SKETCH 02
INTERNAL COURTYARD SETTING OUT
ELEVATION

REV A - 24/09/24
REV B - 01/10/24
REV C - 15/10/24
REV D - 17/10/24

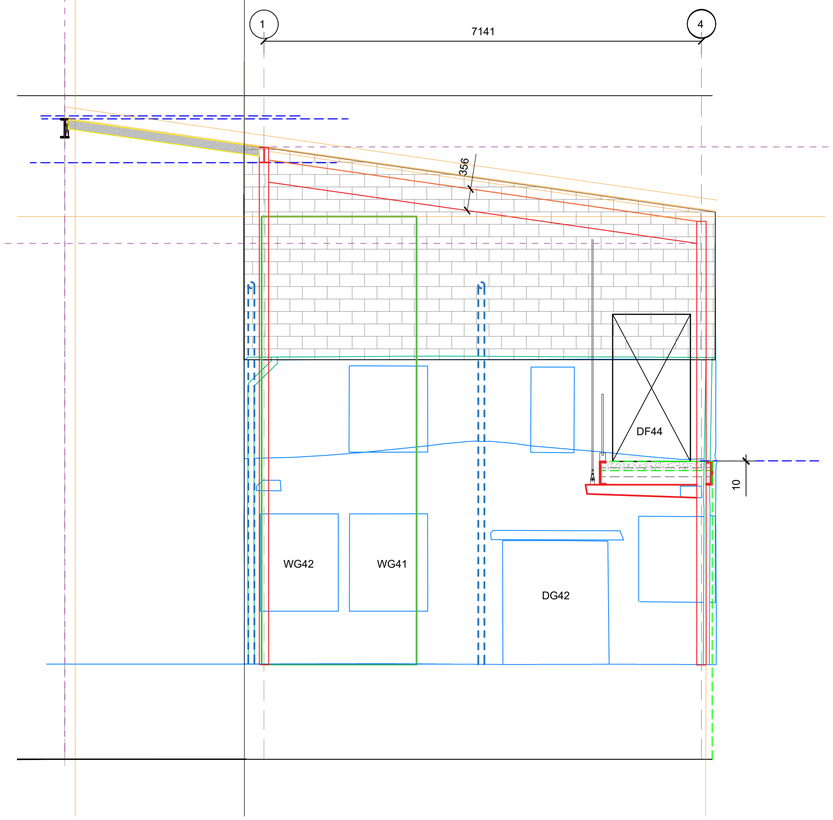
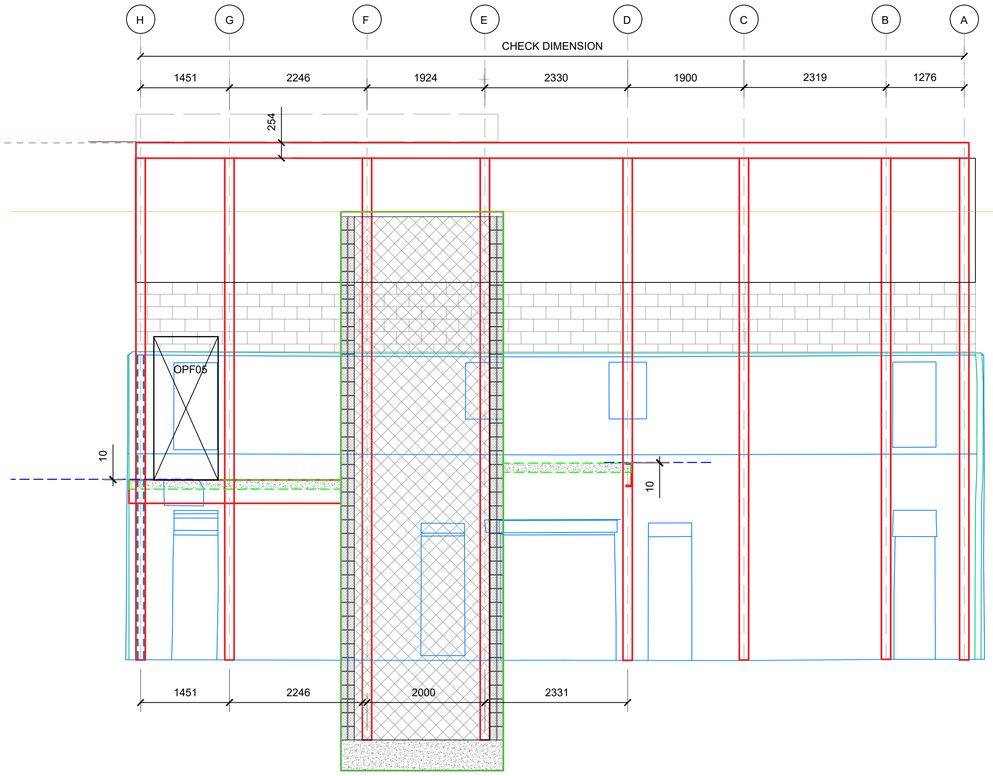
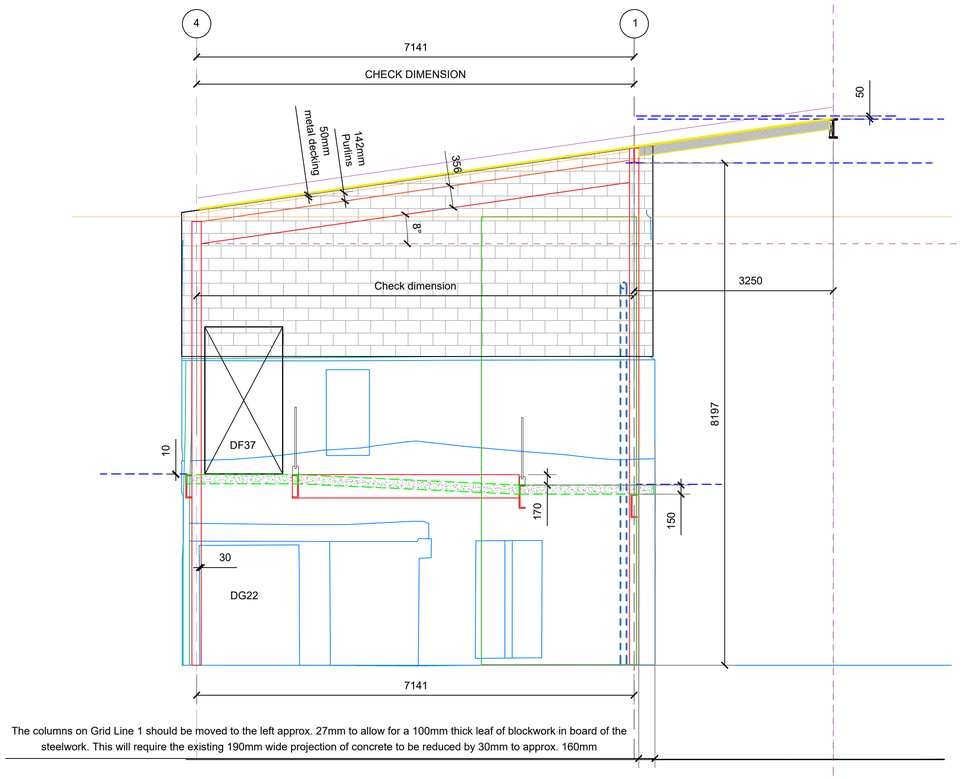
The columns on Grid Line 1 should be moved to the left approx. 27mm to allow for a 100mm thick leaf of blockwork in board of the steelwork. This will require the existing 190mm wide projection of concrete to be reduced by 30mm to approx. 160mm
